FOR: Brookline High School Expansion

| Amendment | Date | |
|-----------|----------|--|
| 12 | 9/4/2019 | New Overhead catenary support (OCS) portal(aka"Bent Relocation") |

Project Name: Brookline High School Expansion Project
Re: Contract Amendment #12

Brookline Hills Station **Change Order 1, 357/175 - 357/176 Bent Relocation**

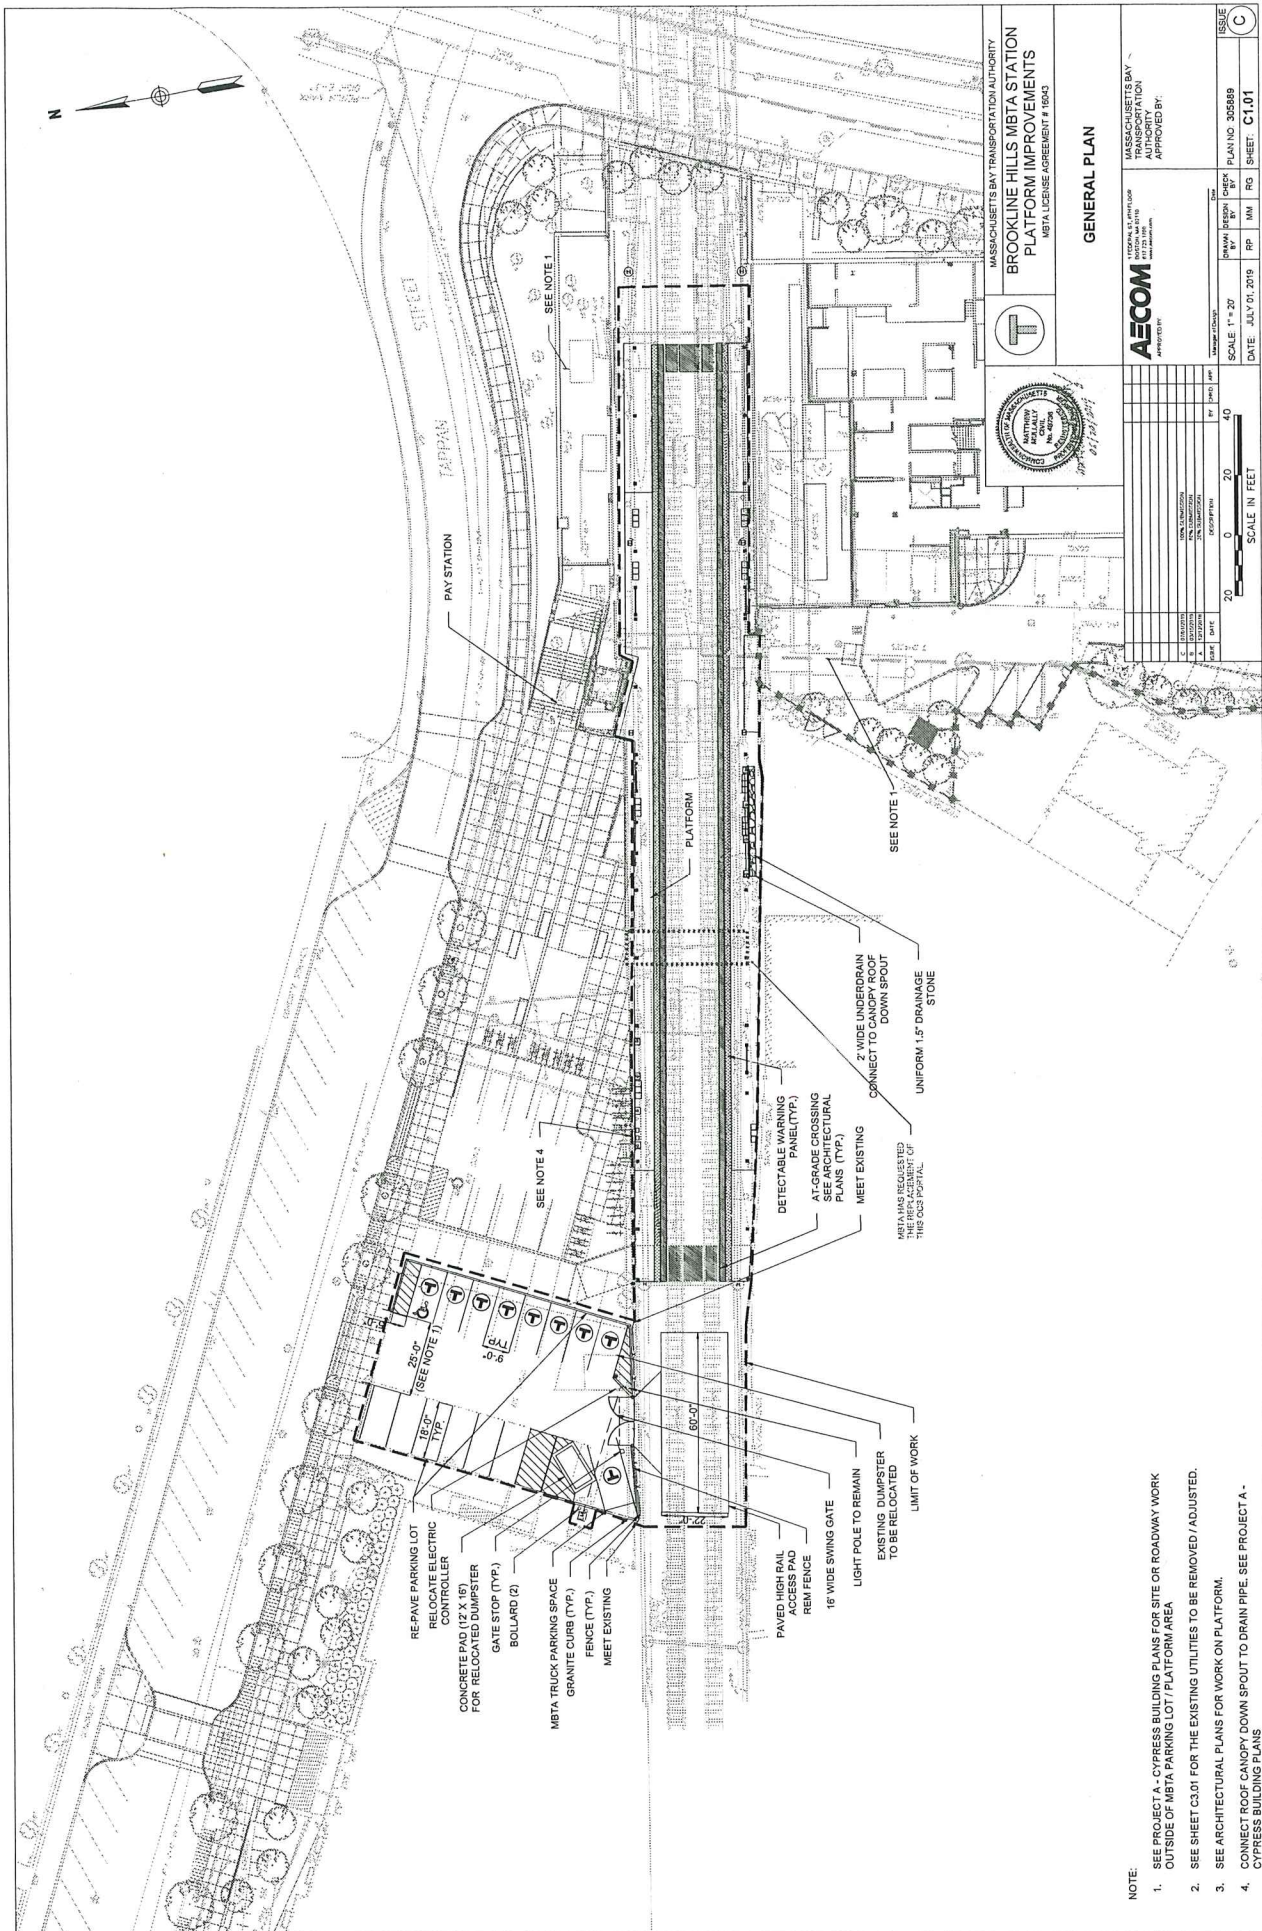
The MBTA has requested that the OCS portal highlighted in the attached diagram be replaced as part of the Brookline Hills platform renovation project. Presently, this portal was planned to remain in place. The MBTA would like a new portal in order to maximize clearances on the platform. Attached is AECOM's proposal for design and engineering services to incorporate this change. At the request of the Building Commission, AECOM has reviewed their original proposal and reduced their fee by \$13,650. I have asked Roger Gagnier to join me at the next BBC meeting to answer any questions members of the commission might have about the proposal.
